SERVICE BULLETIN # 00211

SUBJECT: Installation of a Port Shield

MODELS: GIII

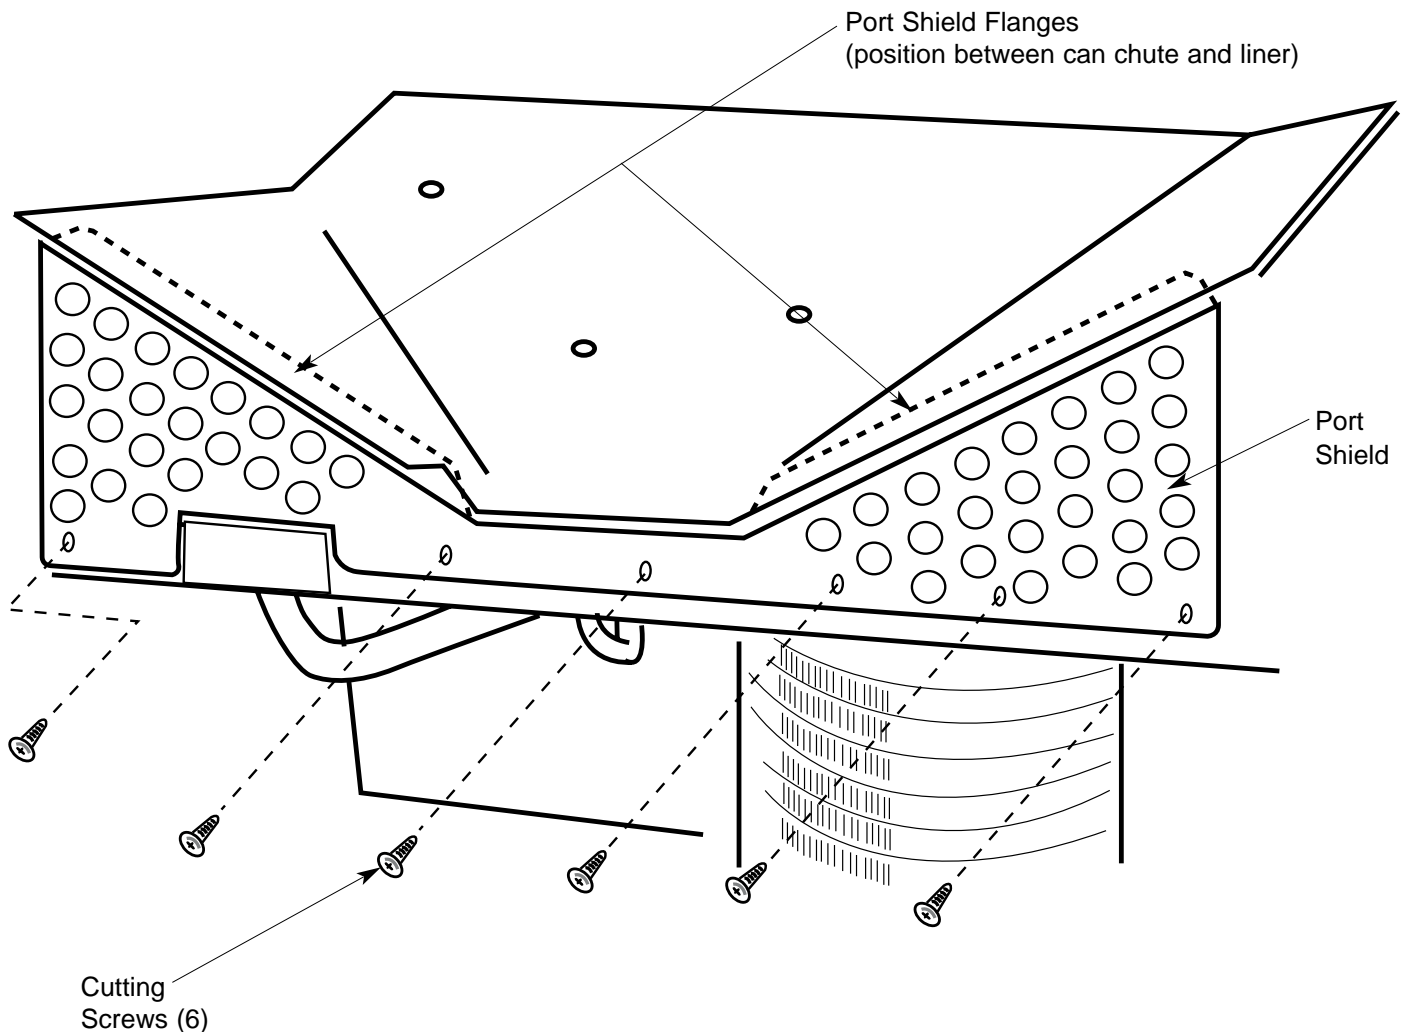
The port shield prevents vandals from reaching through the port opening with a wire and pulling the chute sensor loose to obtain free product and prevents product storage under delivery chute.

1. Remove power from vender by unplugging vender's main power cord from the AC voltage power source.
2. Insert both port shield flanges between the can chute and its liner.
3. Secure the port shield to the cabinet with the 6 cutting screws from the kit.
